## **DISCUSSION of:**

# **Ground Improvement Using Preloading with Prefabricated Vertical Drains**

**Bengt H. Fellenius, Dr. Tech., P.Eng., Canada; email: [bengt@fellenius.net](mailto:bengt@fellenius.net)**

Figure 1. Settlement measured at the benchmarks shifted 10 days.

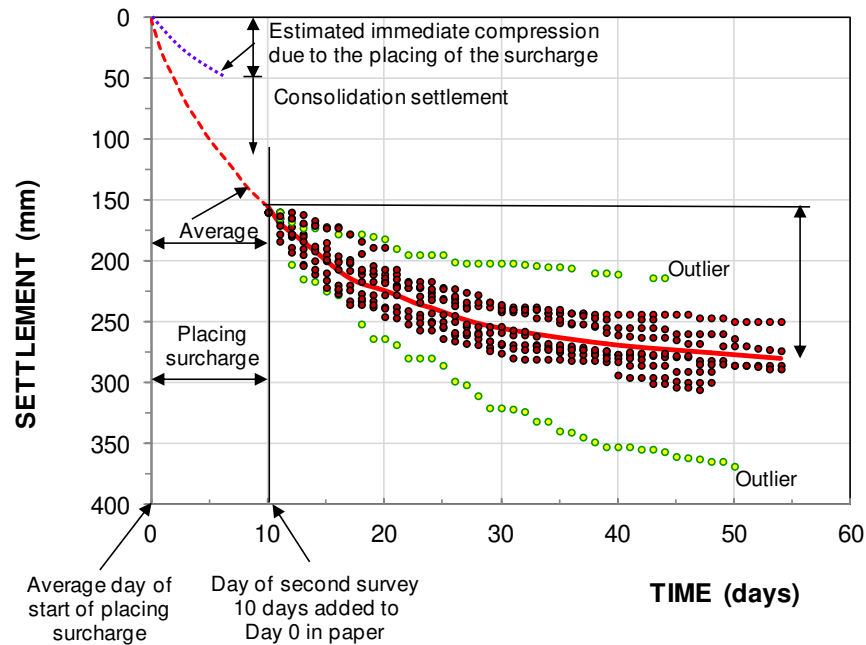
The authors report, that the first survey of the benchmarks was taken before the 3.0-m surcharge was placed across the test area. The first day of settlement measurements for the twelve benchmarks was the date of the second benchmark survey, which was carried out only when all of the surcharge had been placed to the full height over the test area. The time between the first and second surveys—and the placing of the surcharge—ranged from a few days to twenty days. Because the times between the placing of the surcharge and the second survey differed for the benchmarks, the amount of settlement that had occurred at the time of the second survey also differed between the benchmarks. This explains some of the significant scatter displayed in the authors' Figure 13. I have re-plotted the measured settlements in Figure 1 to a common starting point at the average start settlement of 160mm and added 10 days to the authors' measurement days to indicate the average duration of placing the surcharge, which took place before the second survey. During this time, immediate compression and some consolidation will have occurred. As indicated, I estimate the immediate compression to be about 50 mm. I have also added an average curve and extrapolated it back to the origin (the average excludes the two outlier records). All benchmarks appear to show that most of the consolidation had developed at the time the last survey was made.

Figure 2. Settlement measured at the benchmarks normalized to the average end values.

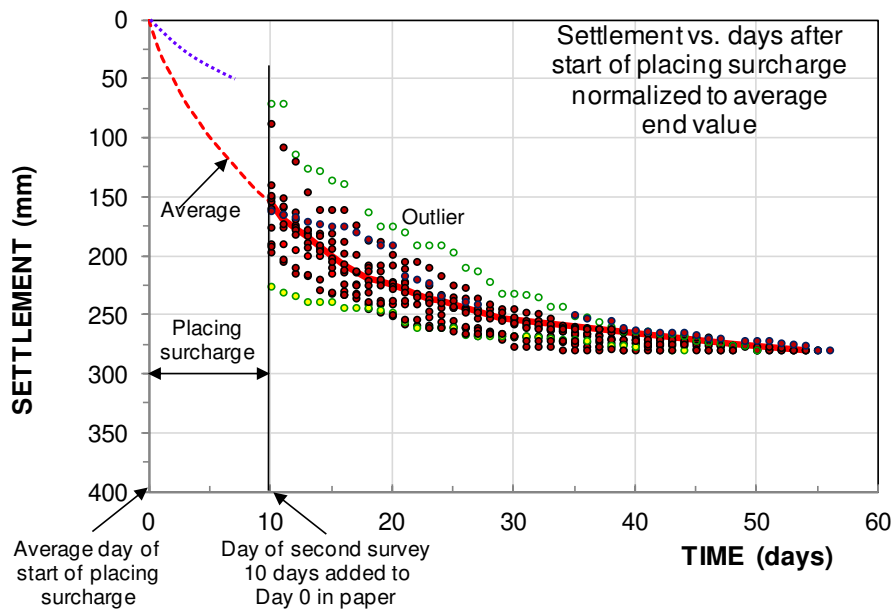
Figure 2 shows the measured final settlements are normalized to the average final settlement (280 mm). There is still much scatter between the curves, but now the approximate start date for each curve can be obtained by sliding the curves left or right until the best agreement to the average curve is obtained as shown in Figure 3. The removal of much of the scatter—the agreement between the time-settlement curves—is of course to some extent fictitious as the benchmark measurements cannot be expected to be all that similar; a natural variation must have taken place, not least with regard to the thickness of the soft clay layer. However, I believe that the figure suggests a reasonably realistic day for the start of placing the surcharge.

Figure 3. Settlement measured at the benchmarks adjusted to obtain the approximate start day.

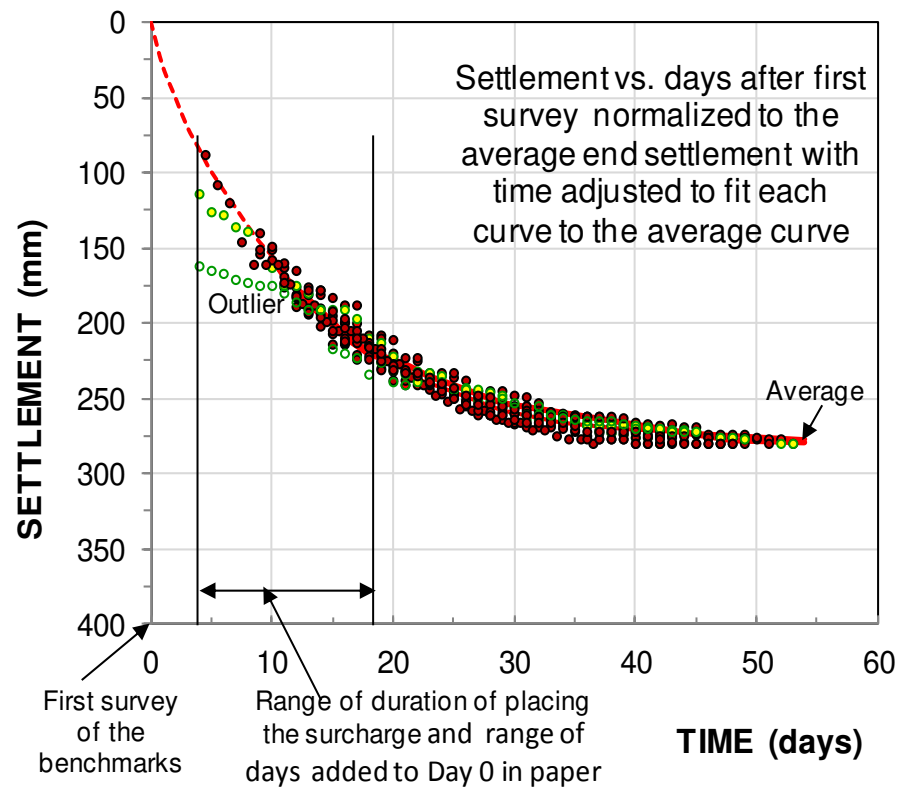
The average curve shown in Figure 3 can now serve as reference to a back-calculation of the time-settlement development for the wick-drain project to determine compressibility and coefficient of consolidation of the soil layers. The back-calculation consists of applying the theory of pore pressure dissipation in fine-grained soils (consolidation) due to radial flow (Barron 1948, Kjellman 1948, and Hansbo 1960; 1979) is based on radial flow toward a circular drain in the center of a cylinder of homogeneous soil with an impervious outer boundary surface). The theory is summarized in the Kjellman-Barron formula, Equation 1. The Kjellman-Barron formula is based on the assumption of horizontal (radial) flow only and a homogeneous soil.

Figure 4. Average measured and calculated settlements.

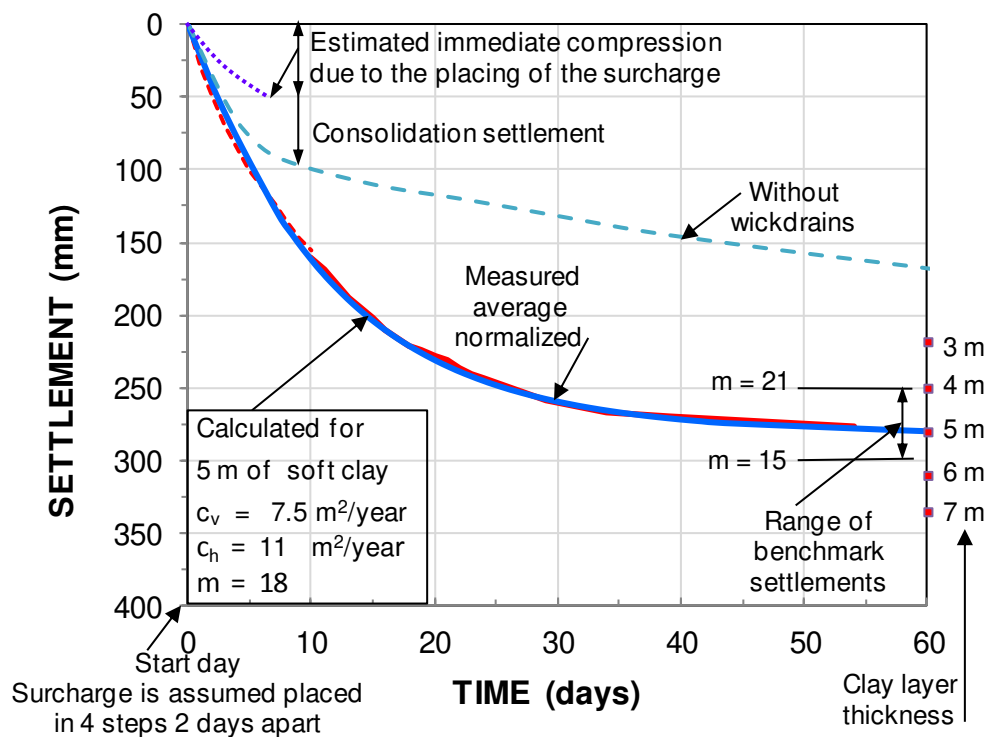
The results of the back calculation are shown in Figure 4 together with the average curve of the measurements. In order to show the sensitivity of the clay layer thickness and modulus number, the figure also shows the final settlement for soil layer thickness ranging from 3 through 7m and the final settlement resulting from modulus numbers of 15 and 21. The figure also shows the settlement during the first 60 days that would have occurred had there been no wick drains (for this input, I used the authors' 7.5  $m^2/year$   $c_v$ -coefficient).

Considering that my data reduction is quite different to that of the authors, my back-calculated  $c_h$ -coefficient (11  $m^2/year$ ) agrees well with the authors' laboratory-established value (14  $m^2/year$ ). The difference could be taken to represent the effect of a smear zone. However, considering all the uncertainties involved, I believe the agreement to be entirely fortuitous.
